**TECHNICAL BULLETIN**  
**Bell Helicopter** **TEXTRON**

No. 212-04-198

**MODEL AFFECTED:** 212

**SUBJECT:** HEATED WINDSHIELD INDICATORS,  
REPLACEMENT FOR SPARES

Fig 3

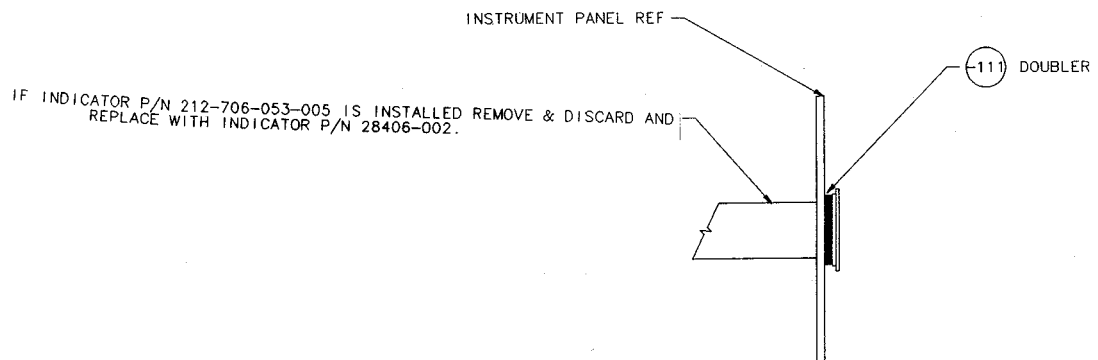
1. Disconnect battery.
2. Gain access to the back of Heated Windshield indicator located on the instrument panel.
3. Disconnect wires from Heated Windshield indicator.
4. Using fig 2, delete wires as mentioned.
5. Remove and discard Heated Windshield indicator from instrument panel.
6. Install new Heated Windshield indicators in conjunction with doubler –111 as shown in fig 3.
